CALIFORNIA DRIVE ROUNDABOUT IMPROVEMENTS – **CITY PROJECT NO. 83920**

ADDENDUM NO. 3

February 13, 2018

CD-03

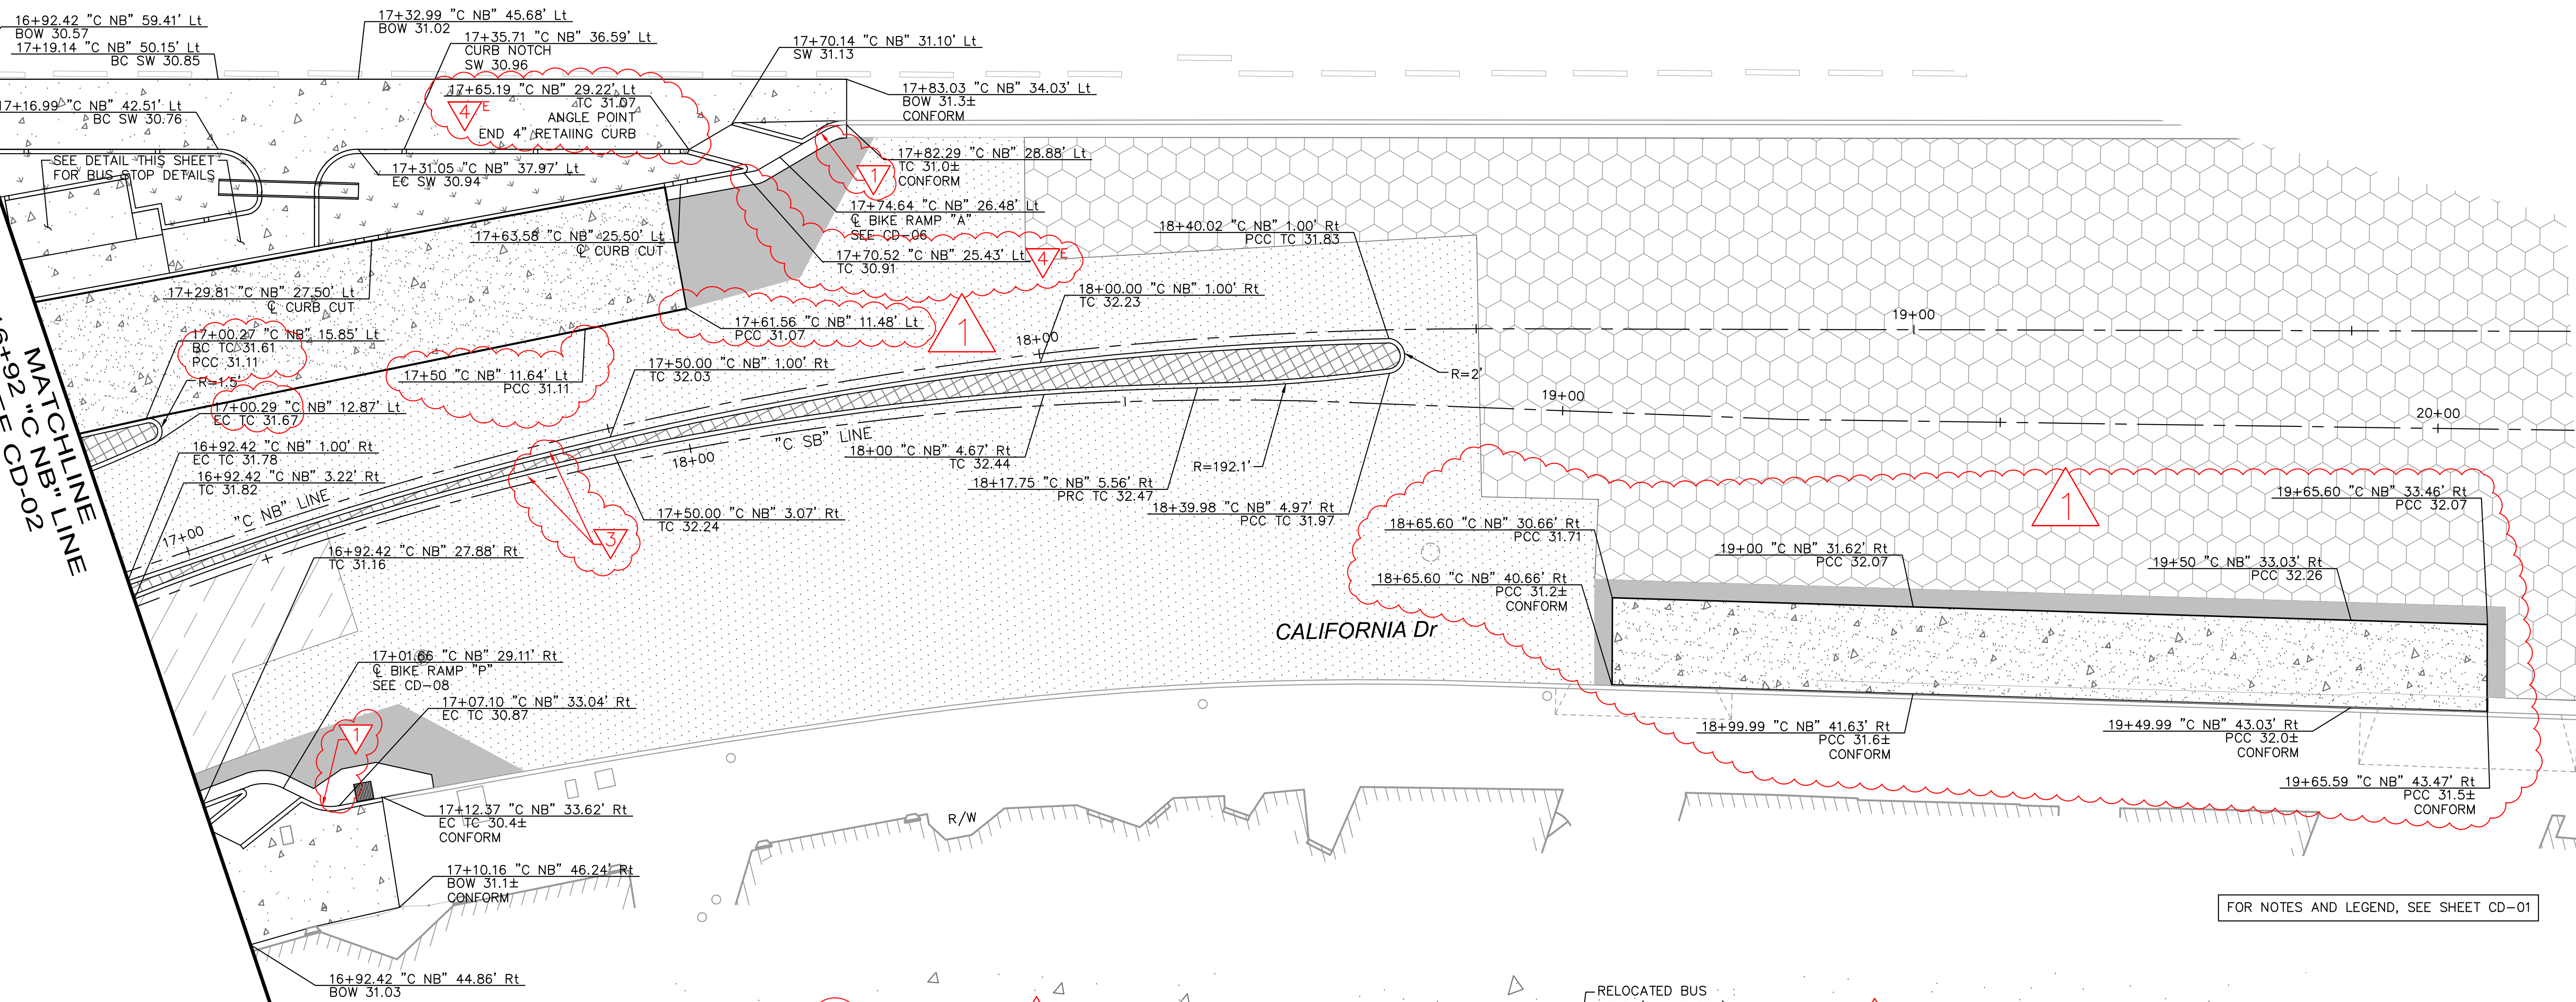
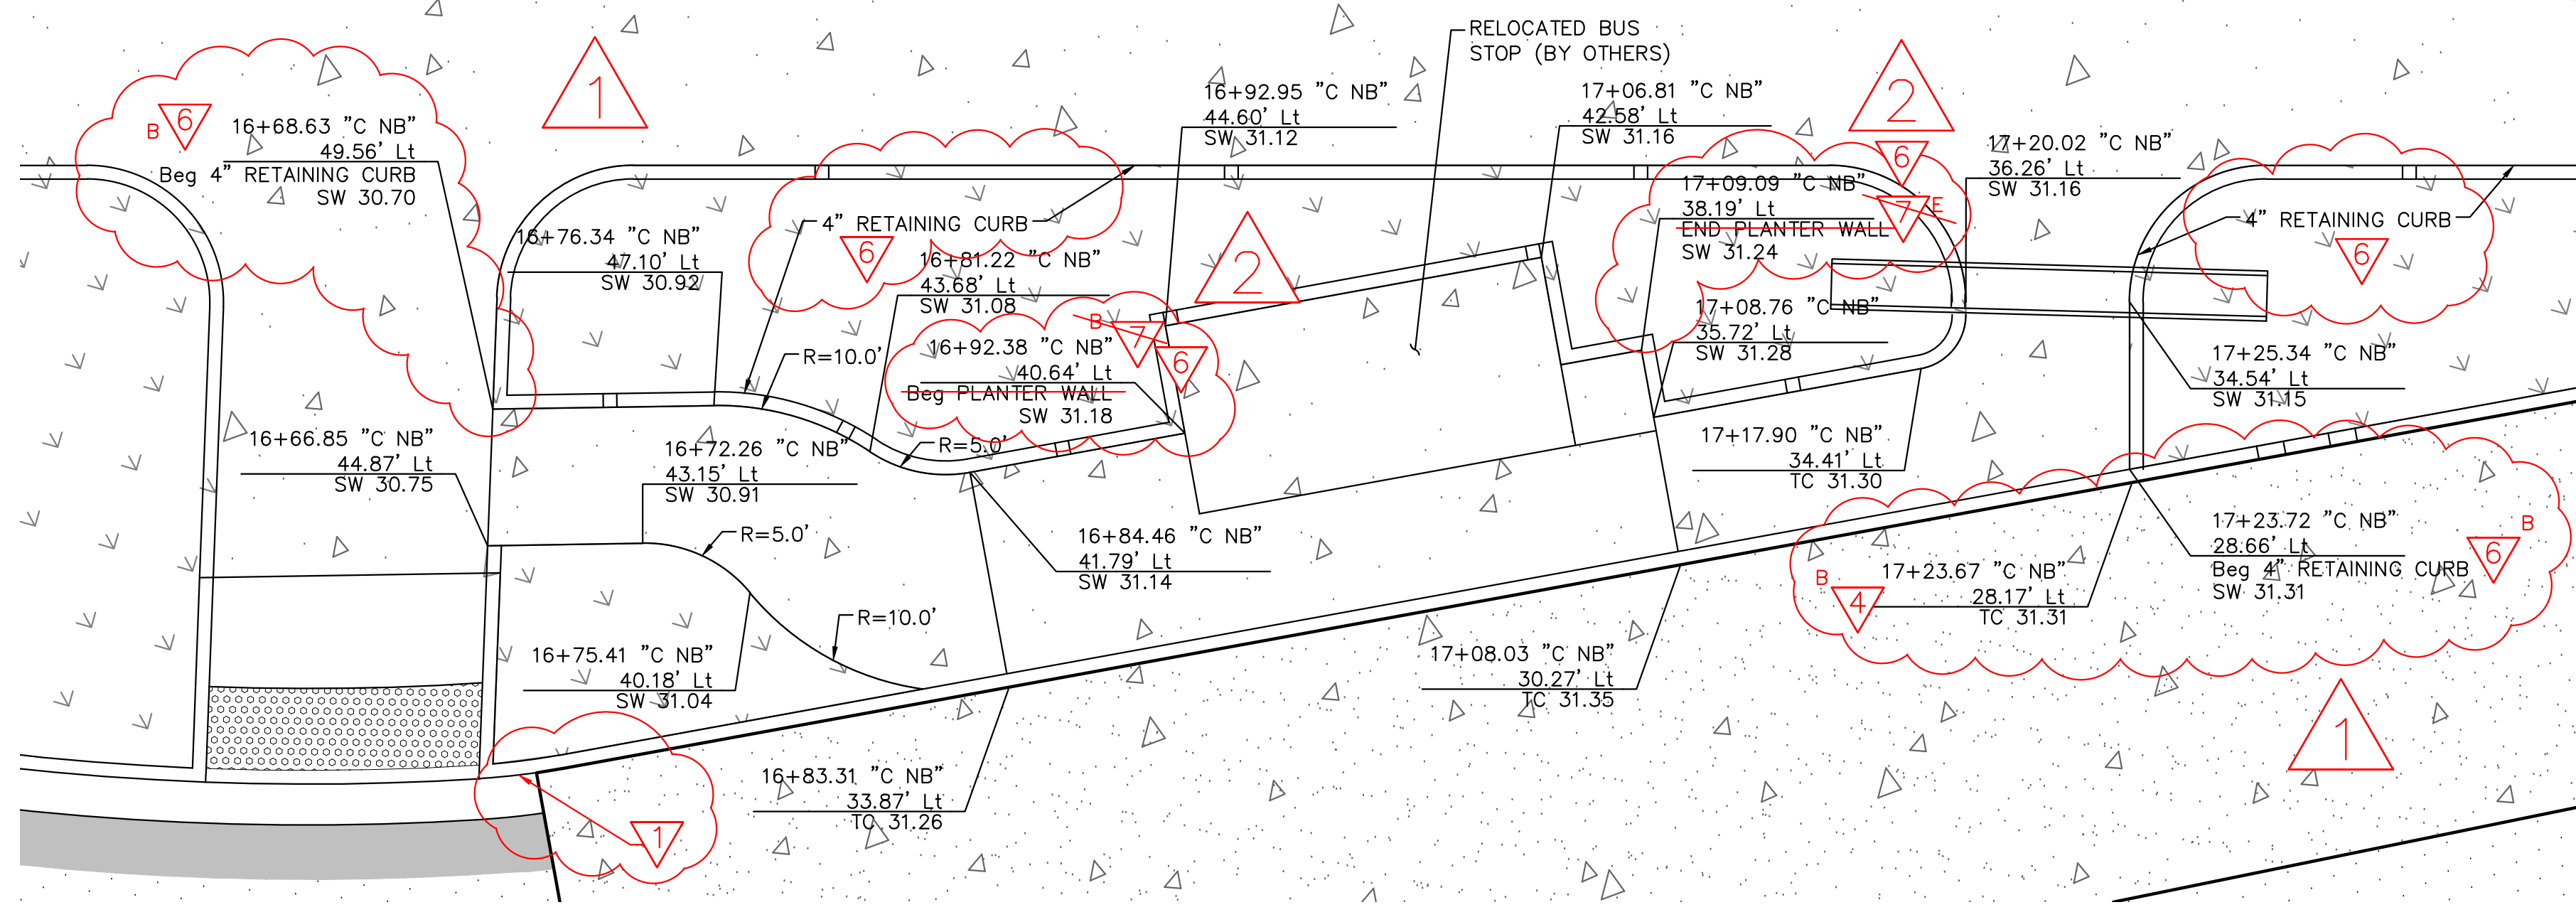
5. **Replace SHEET 13 (CD-03) with attached revised SHEET 13.**
6. **Replace SHEET 19 (CD-09) with attached revised SHEET 19.**
7. **Replace SHEET 26 (U-01) with attached revised SHEET 26.**

SHEET NO. 26
OF 61 SHEETS
U-01

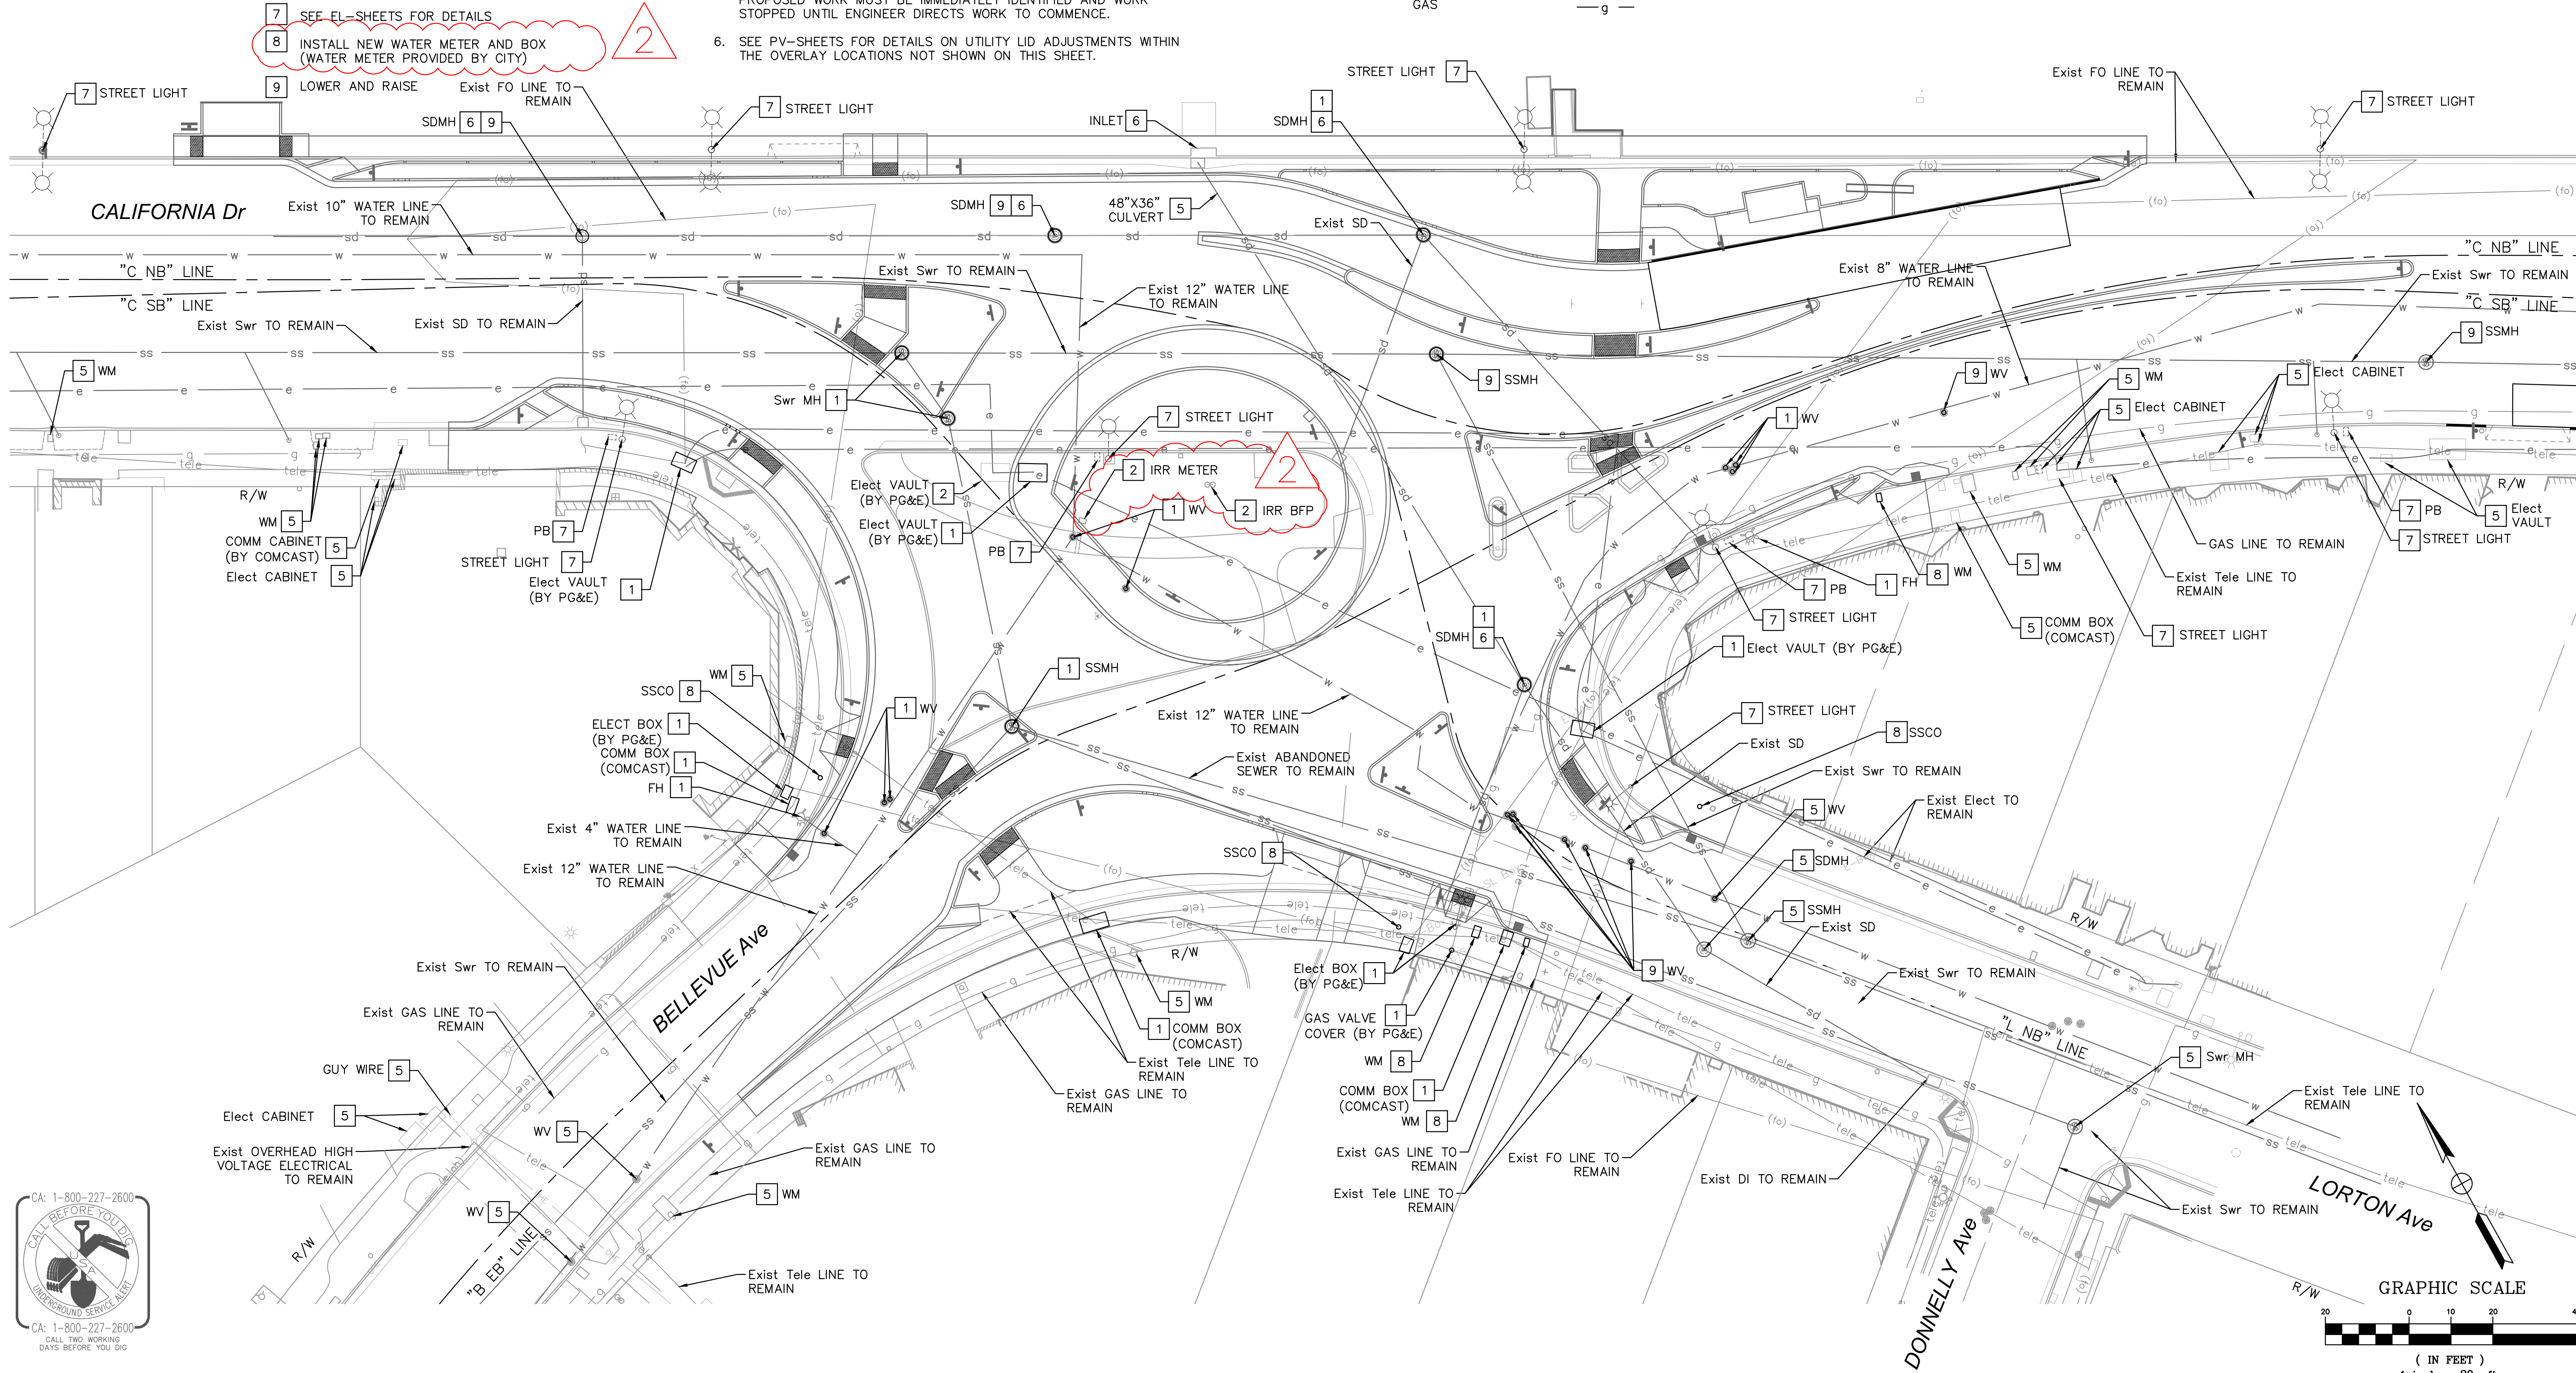
7. *The irrigation water meter appears to be existing on utility plan sheet U-01, can this be confirmed? If the meter is not existing can a make and model be stated? Also, will a water main tap be necessary?*

Response: City to furnish new irrigation water meter and contractor is to install. See changes in TECHNICAL SPECIFICATIONS section below.

- 1 ADJUST TO GRADE
- 2 REMOVE UTILITY FACILITY
- 3 INSTALL UTILITY FACILITY
- 4 RELOCATE UTILITY FACILITY
- 5 TO REMAIN
- 6 SEE D-SHEETS FOR DETAILS
- 7 SEE EL-SHEETS FOR DETAILS
- 8 INSTALL NEW WATER METER AND BOX (WATER METER PROVIDED BY CITY)
- 9 LOWER AND RAISE
